AGENDA ITEM: Inwood 4th Addition Final Plat and Final Planned Unit Development Plans
SUBMITTED BY: Stephen Wensman, Planning Director
THROUGH: Kristina Handt, City Administrator
REVIEWED BY: Jack Griffin, City Engineer
Emily Becker, City Planner
Mike Bent, Building Official
Greg Malmquist, Fire Chief
Sarah Sonsalla, City Attorney

PLANNING COMMISSION
DATE: 10/10/16
AGENDA ITEM: 4A– PUBLIC HEARING ITEM
CASE # 2016-38

ITEM: Inwood 4th Addition Final Plat and Final Planned Unit Development Plans
SUBMITTED BY: Stephen Wensman, Planning Director
REVIEWED BY: Jack Griffin, City Engineer
Emily Becker, City Planner

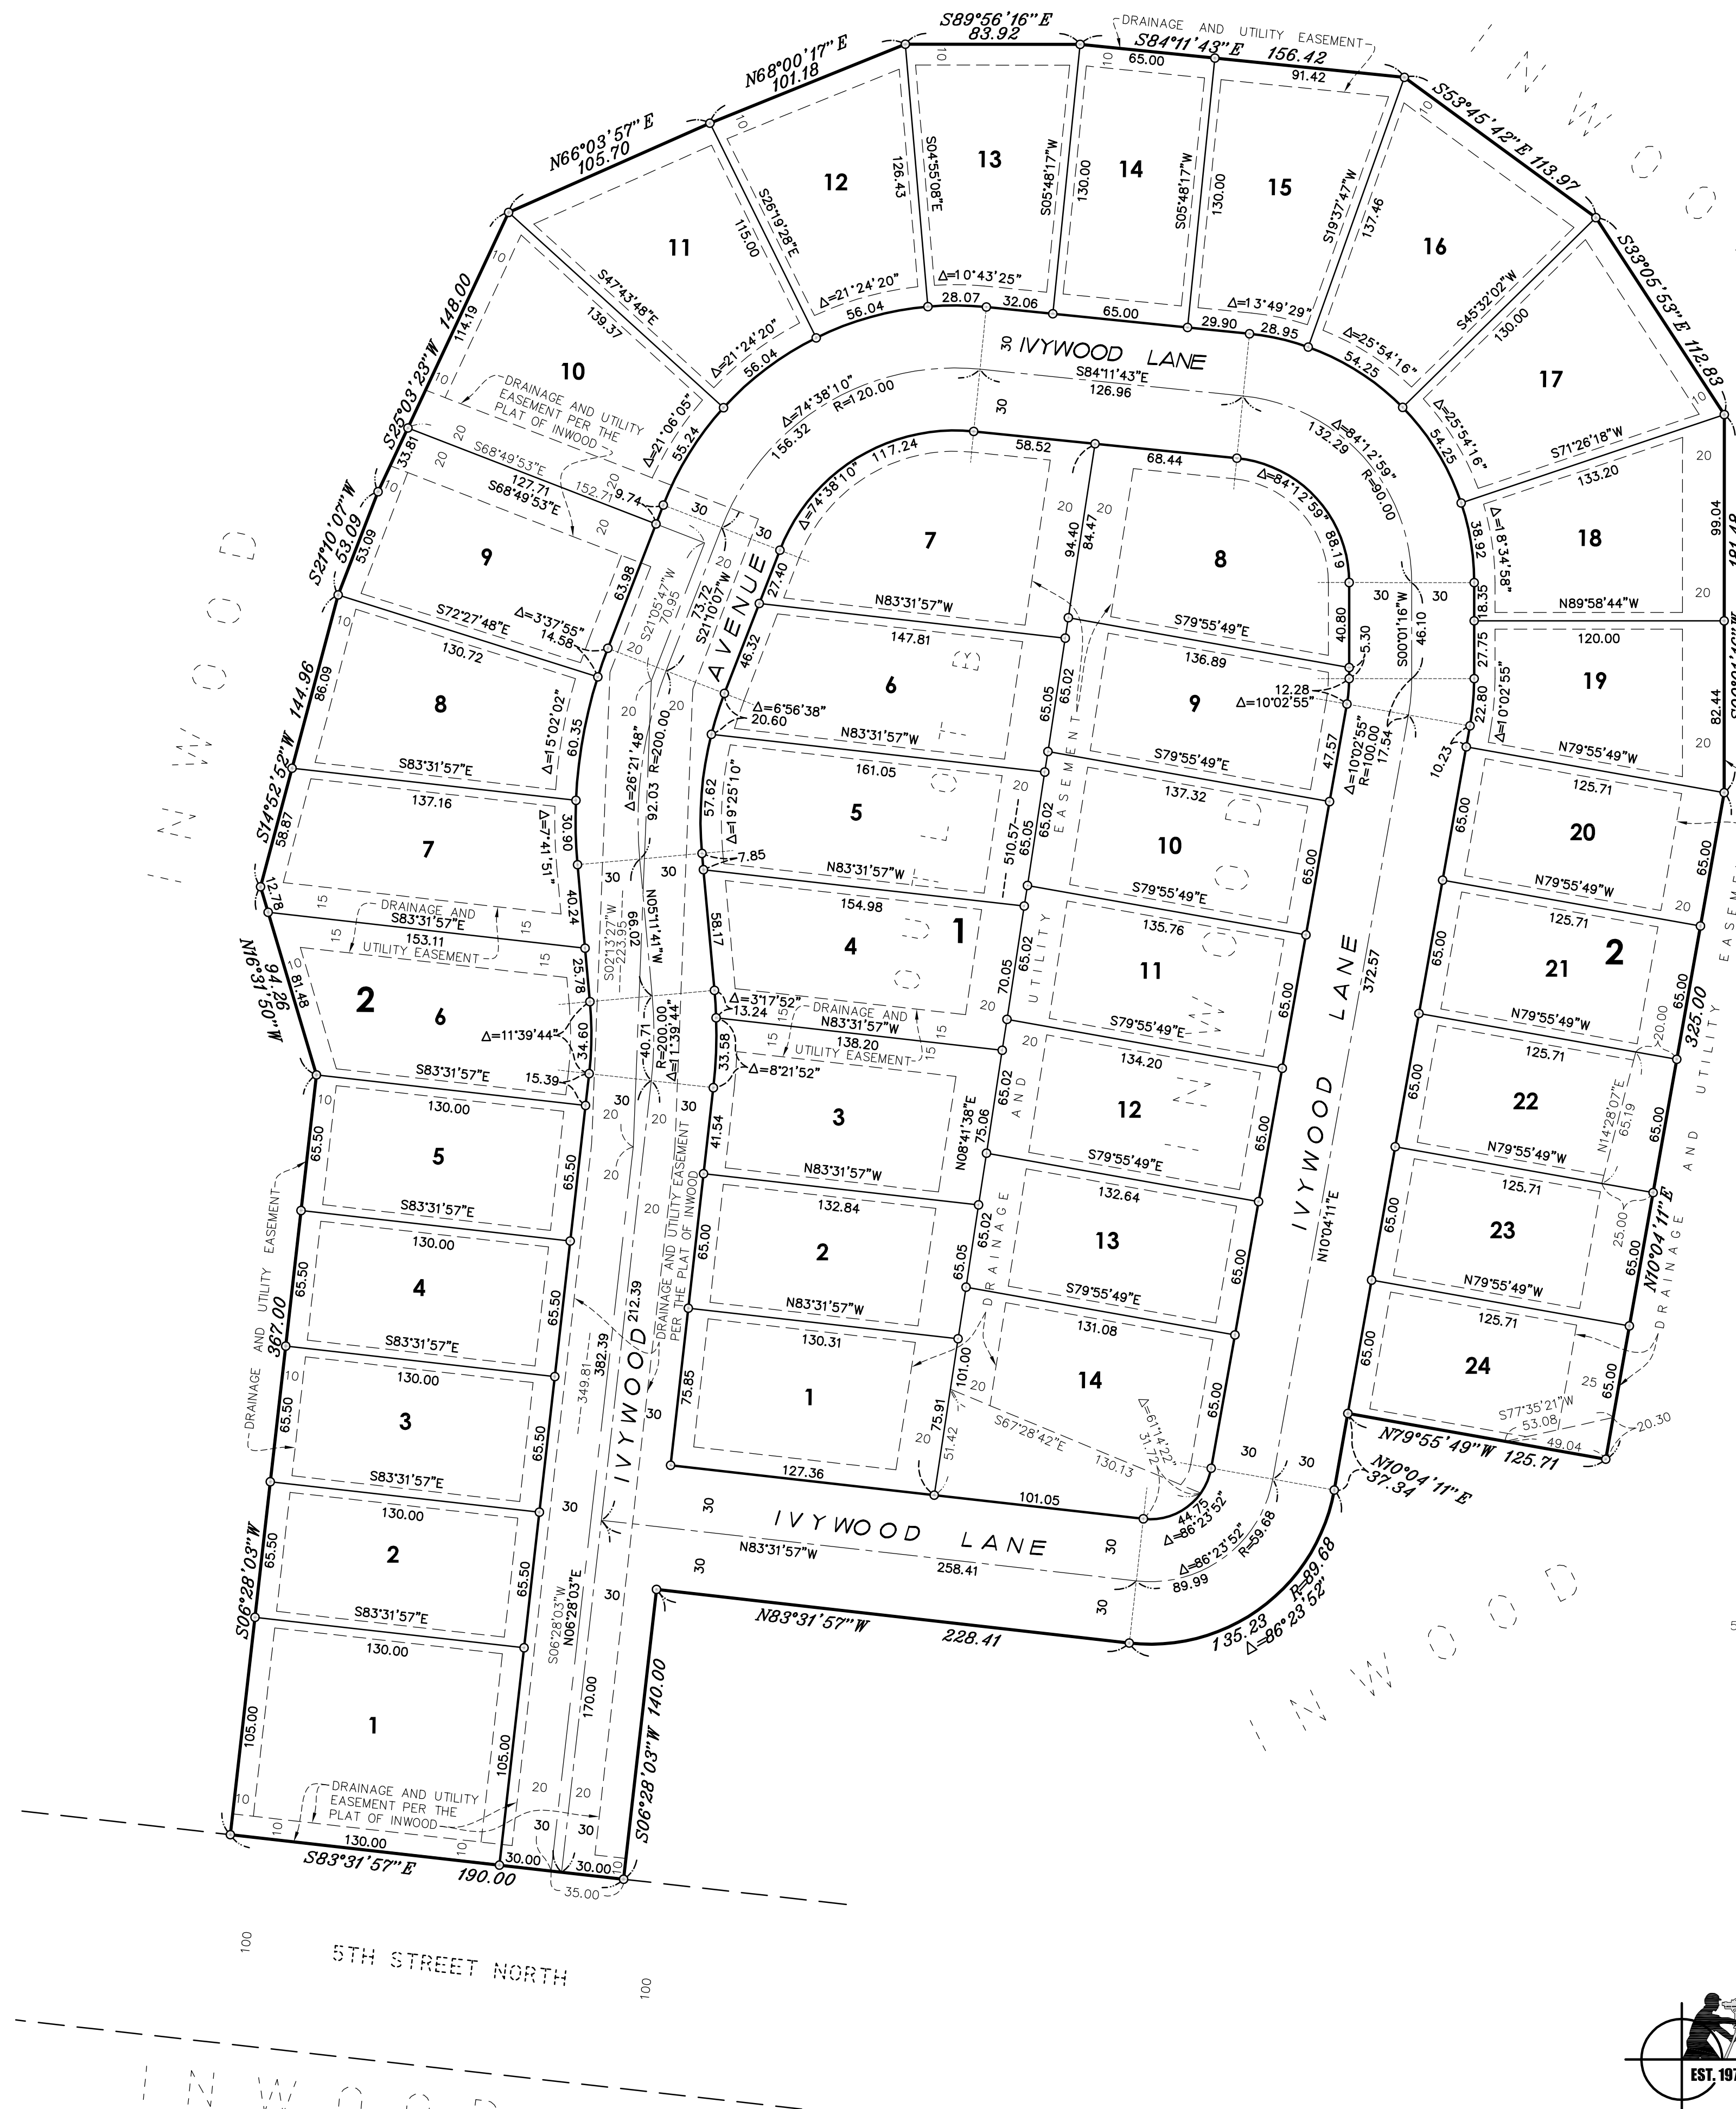
- 1) All easements as requested by the City Engineer or Public Works Department shall be documented on the Final Plat prior to the execution of the final plat by City Officials.

- 2) All conditions/comments from the City Engineer's review memorandum dated September 28, 2016 be complied with prior to the execution of the final plat by City Officials.

SANITARY SEWER NOTES

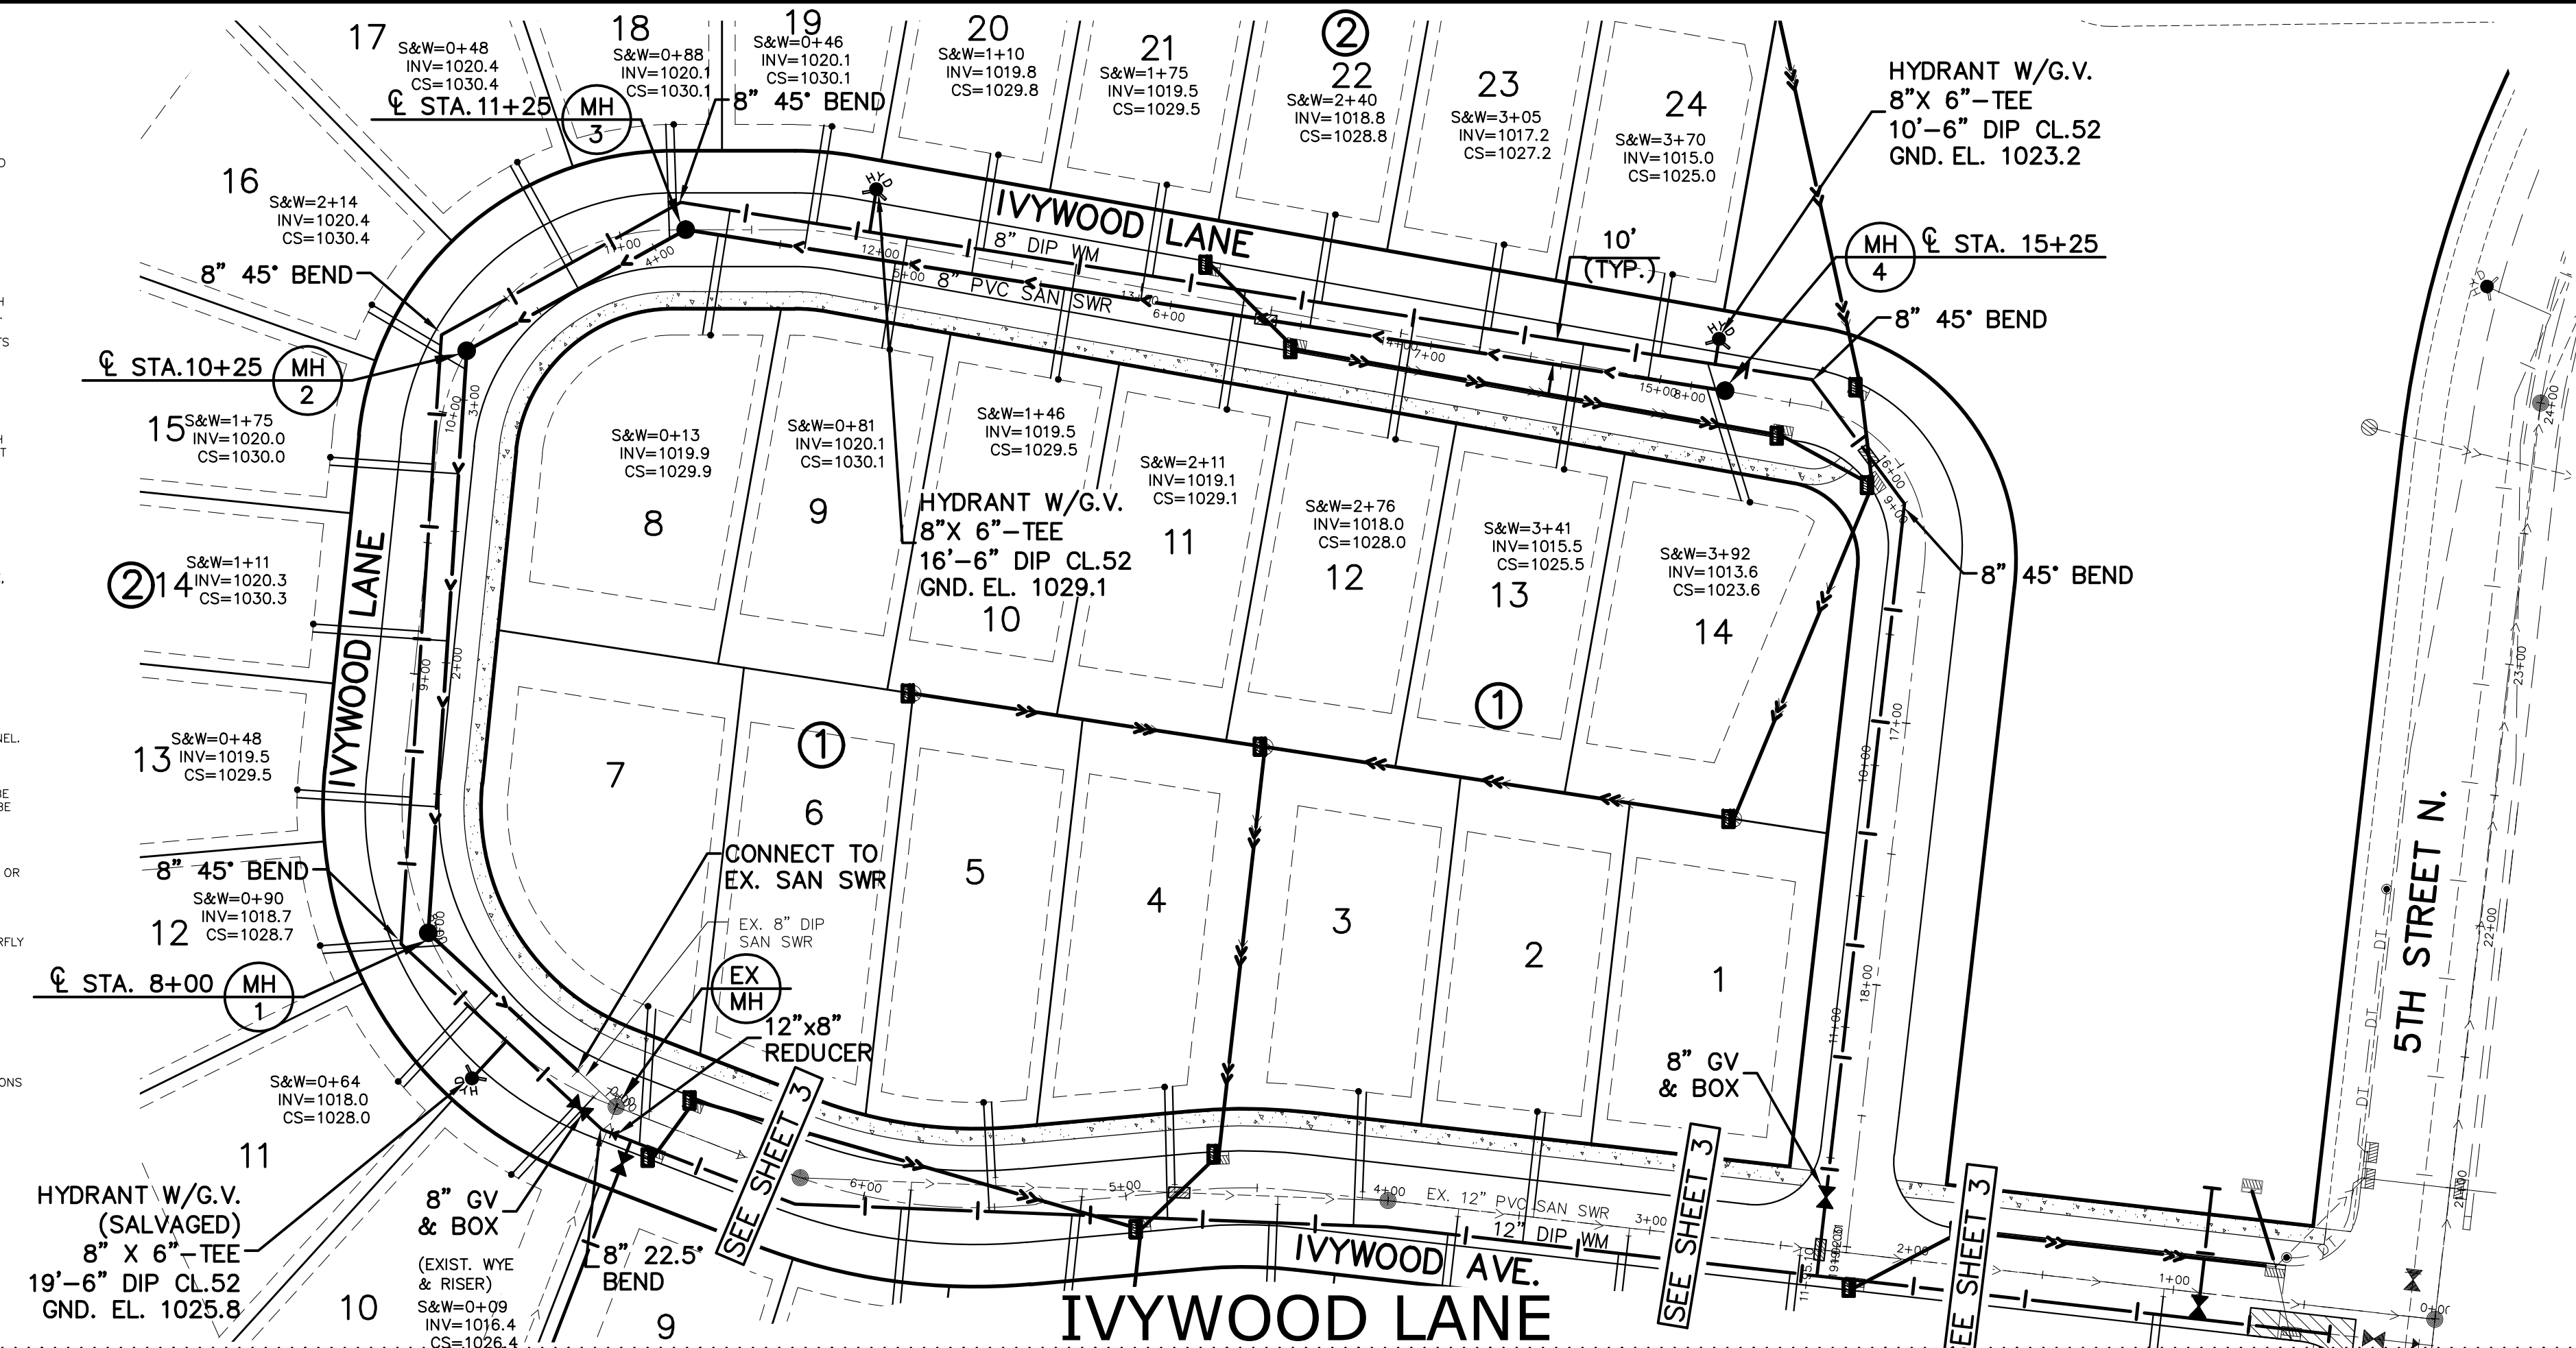
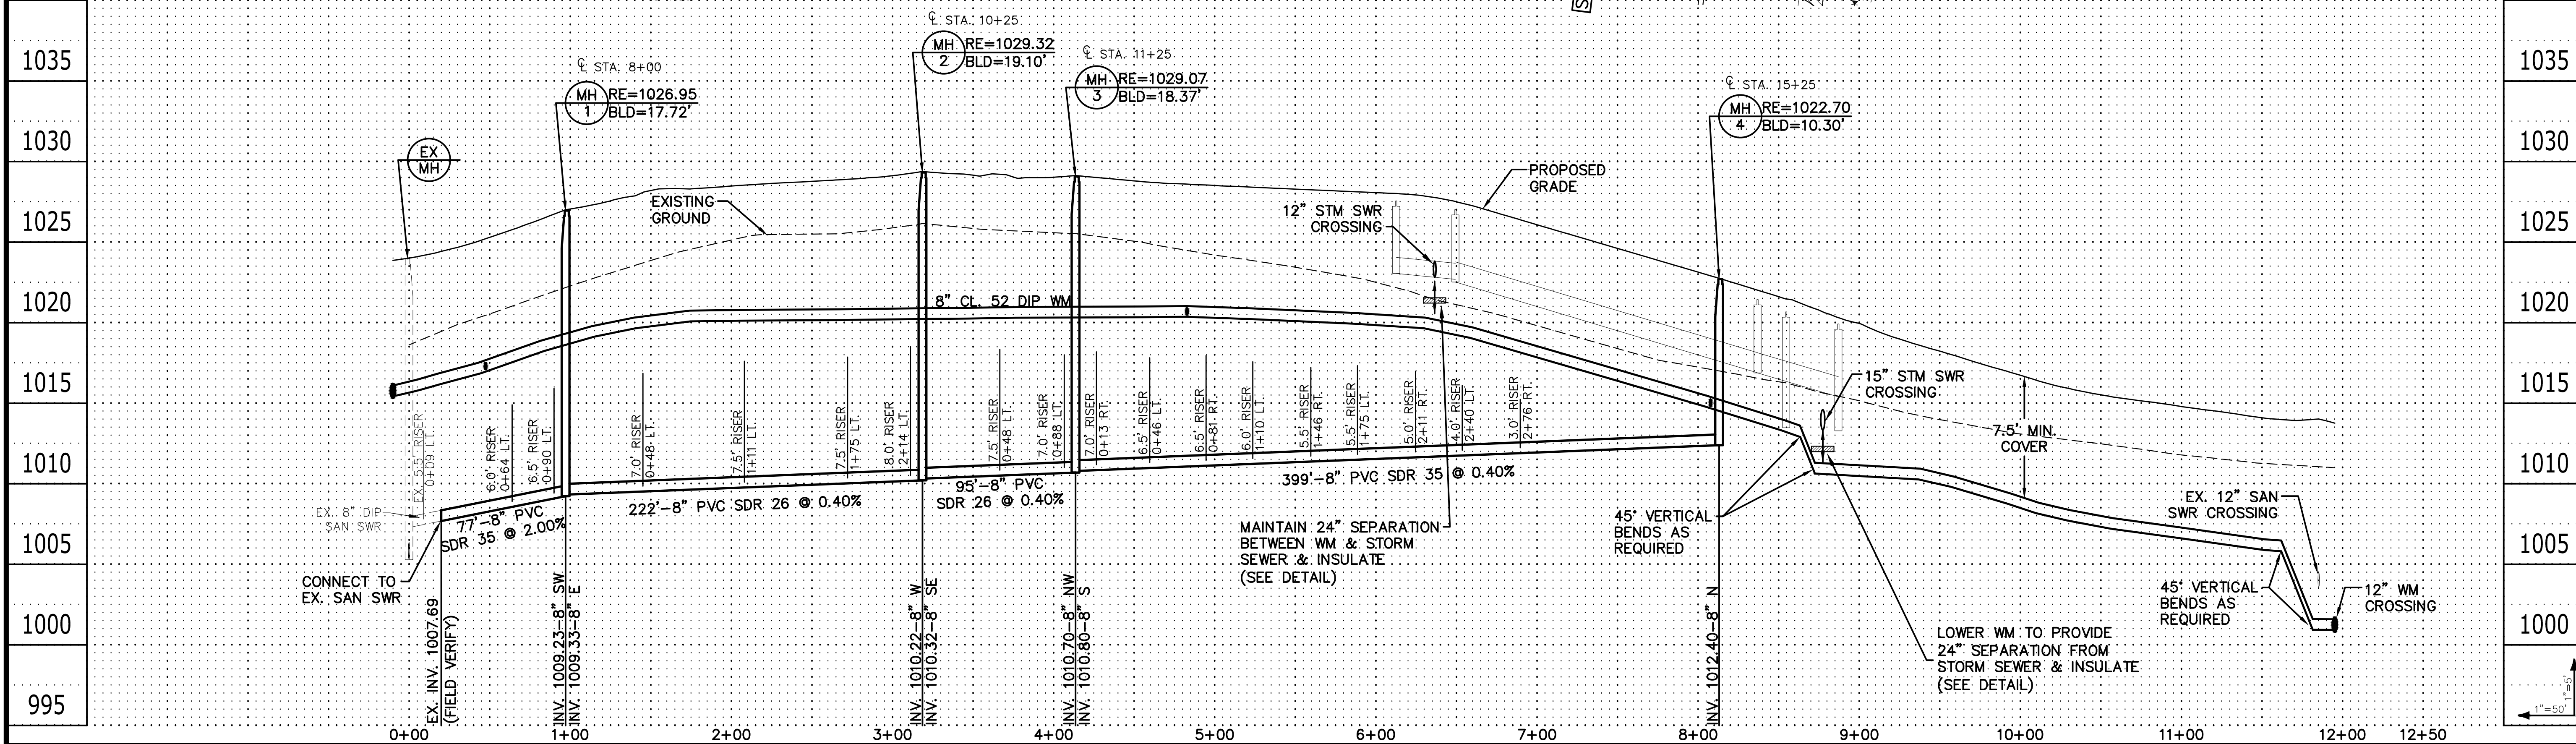
There are a couple changes we would like to see to the water and street plans.

Water – Add a 12” gate valve on the north side of Ivywood Ave. at its intersection w/ Ivywood Ln. As the current plans show, we would be shutting water off to the entire addition it work/repairs would be needed in the area from 5th St. north to were the 12” main ties in from the easement on the west. Adding this valve would help us isolate the area and better control water flowage.
